## EC42-09/10 Part I & Part II

### EECC Requested Final Action: Approved as Submitted

### Table 402.1.1; IRC Table N1102.1

**TABLE 402.1.1  
INSULATION AND FENESTRATION REQUIREMENTS BY COMPONENT<sup>a</sup>**

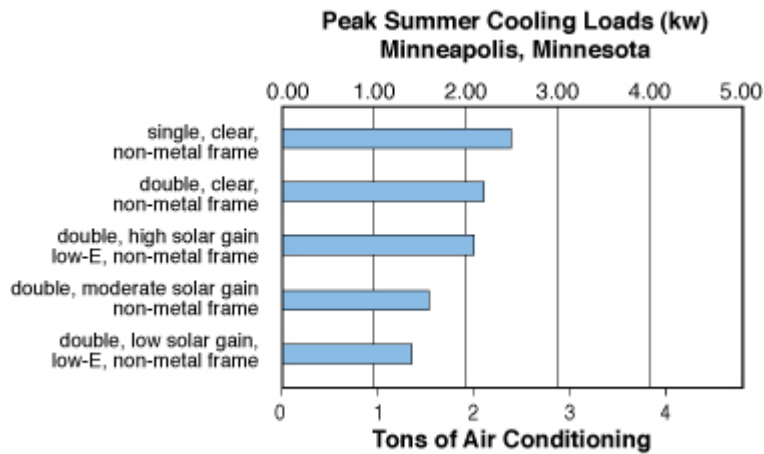
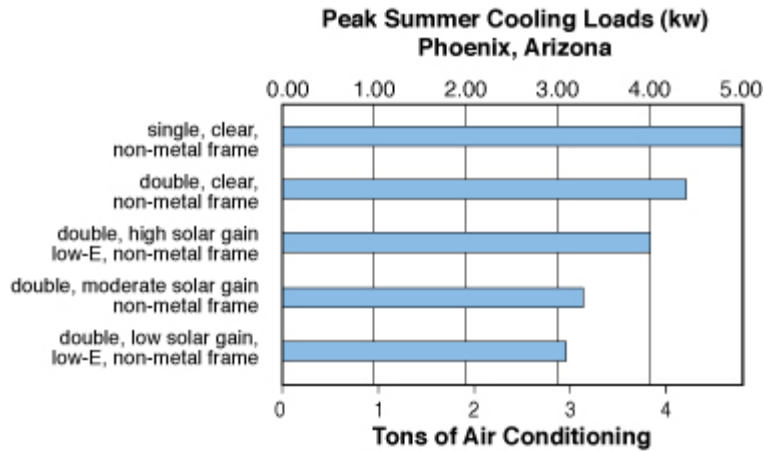
This graph shows a reduction in the likelihood of discomfort from over 60% for a clear product down to almost 20% from a moderate solar gain (0.40 SHGC) product. As the EWC states on its website: “In summer, strong direct sunlight strikes people and interior surfaces, creating overheating and discomfort. Windows with low solar heat gain coefficients will reduce the solar radiation coming through the glass and associated discomfort. Low solar heat gain low-e glass (spectrally selective) reduces heat gain while still providing sufficient light and view.”

The following graphs, also from the same website (see: <http://www.efficientwindows.org/hvac.cfm>), show the peak demand and HVAC savings potential from lower SHGCs in all climate zones. While the graphs demonstrate the benefits in Phoenix (climate zone 2) and Minneapolis (climate zone 6) – southern and northern climates – similar benefits would occur for climate zones in between like zone 4:

**Precedent for a Maximum SHGC Requirement in Climate Zone 4.**

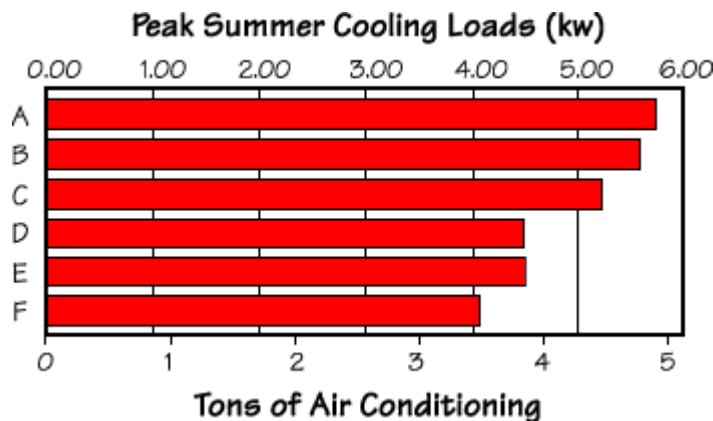
DOE/EPA’s ENERGY STAR for Windows program has included an SHGC maximum requirement in the North-Central zone (roughly *IECC* climate zone 4) for a number of years. The most recent Energy Star qualification criteria, released in April 2009, requires a maximum 0.40 SHGC in the North-Central zone. The 2009 American Recovery and Reinvestment Act (Stimulus Bill) goes even further, requiring a maximum 0.30 SHGC nationwide for the enhanced window tax credit. Chapter 5 of the *IECC* (Commercial Energy Efficiency) already requires a maximum SHGC of 0.40 in climate zones 4-6. ASHRAE 90.1-2007 also contains the same requirement in climate zones 4-6 for both high rise residential and commercial construction. See Table 5.5-4. It is time for the residential chapters of the *IECC* and *IRC* to move in the same direction.

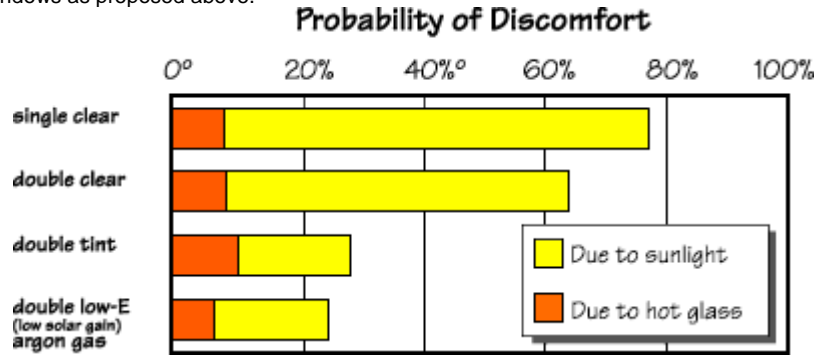
Windows with low SHGC are an obvious answer to this growing problem. The following chart, developed by the U.S. Department of Energy’s Lawrence Berkley National Laboratory (LBNL), which is found on the Efficient Window Collaborative (EWC) website ([www.efficientwindows.org](http://www.efficientwindows.org)), shows the potential for saving peak demand (and tons of HVAC) for different window types. Window E is a higher solar gain low-e double-pane window that meets the current U-factor requirement in climate zone 4. Window F is the low SHGC, low U-factor window that would meet the current U-factor requirement plus the SHGC maximum of this proposal. The reduction in peak cooling load is nearly half of a kW, reducing by almost a half ton the size of the air conditioning unit. As is readily apparent, improved windows will lead to smaller HVAC sizes (with lower costs to the homeowner) and lower peak cooling loads (saving the state from building additional peak capacity).
